This Service Information bulletin supersedes SI 34 01 12 **dated March 2012**.

Service Action: Replace Integrated Chassis Control Module (ICM)

6 Series (F13)

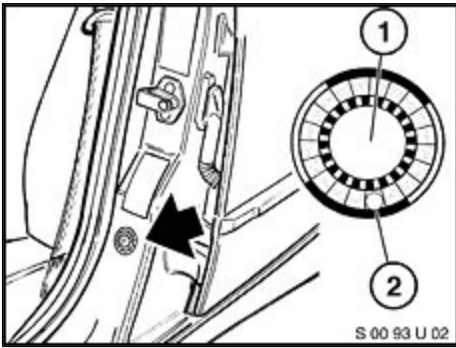
This Service Action has been assigned code number **607**. After the vehicle has been checked and/or corrected, obtain a label (SD92-403) and:

- A. Emboss your BMW center warranty number in the middle of the label (1);
- B. Punch out code number **607** (2), printed on the label; and
- C. Affix the label to the **B**-pillar as shown.

If the vehicle already has a label from a previous Service Action/Recall Campaign, affix the new label next to the old one. Do not affix one label on top of another one because a number from an underlying label could appear in the punched-out hole of the new label.
